AGENDA  
HISTORIC PRESERVATION / DESIGN REVIEW COMMISSION

October 5, 2016 – 4:00 PM

**Install Signs  
Design Review Request  
1009 Clark Street  
September 29, 2016**

**Replace Siding, Trim & Porches  
Design Review Request  
1801 Clark Street  
September 29, 2016**

**2 MAIN LEVEL FLOOR PLAN**  
A1.0 1/8" = 1'-0"

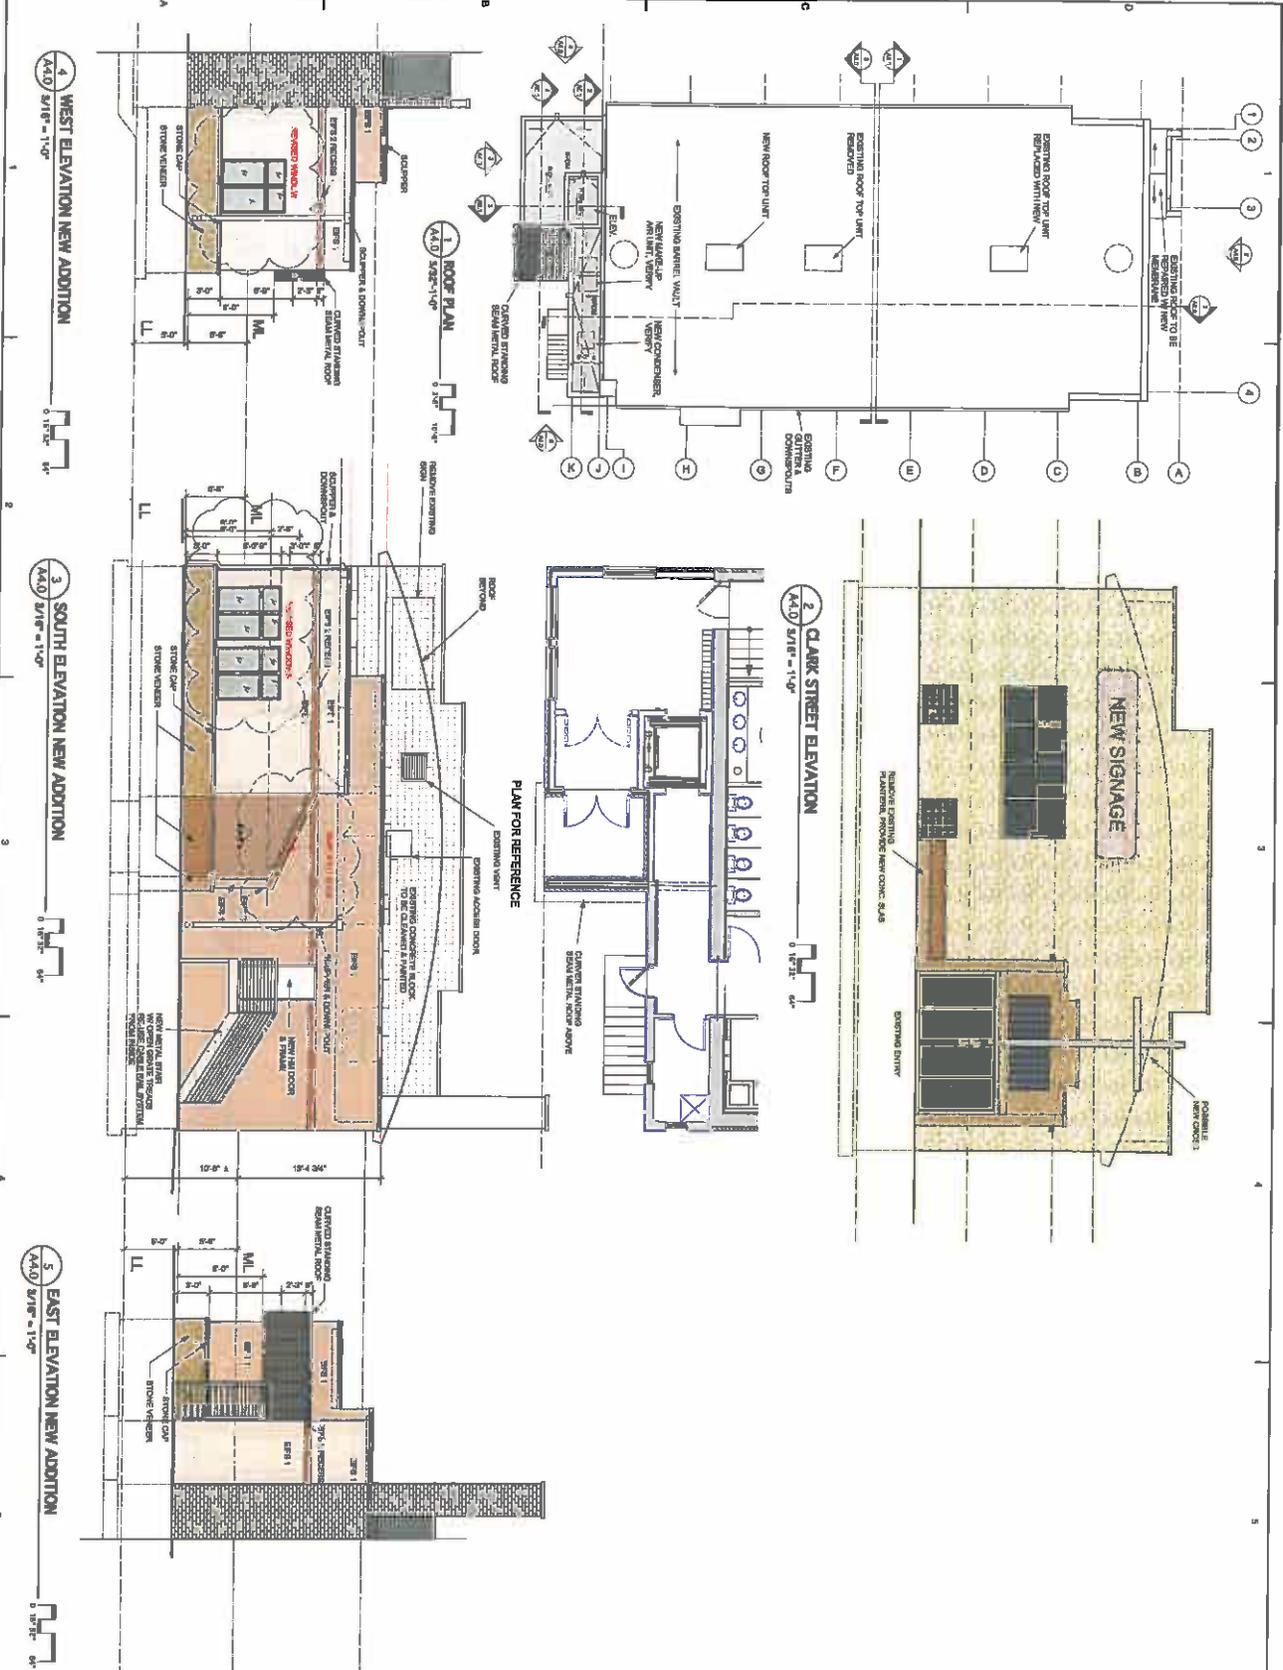
1. Downspouts shall match the color of existing spouts (dark brown), or blend into the façade colors.
2. Stone veneer or other approved masonry by the chairperson and designated agent shall be installed on the entire addition façade, replacing the EIFS.

3. Door and window trim and framing shall match the existing color found on existing windows and doors.
4. Rooftop or ground mechanical equipment shall be completely screened appropriately with fencing or other approved device by the chairperson and designated agent.

5. The existing landscaping planter on the north façade shall be restored rather than removed.
6. Building codes and zoning ordinance and sign ordinance requirements shall be met.

7. All applicable building permits shall be obtained.
8. Staff shall have the authority to approve minor amendments to the project.
9. Signage for the property is not approved and shall be reviewed appropriately at a later date.

10. Existing exposed block shall be painted a color matching the existing brick, to be reviewed and approved by the chairperson and designated agent.
11. Trash receptacles and storage shall be screened with materials matching the materials on the primary structure.
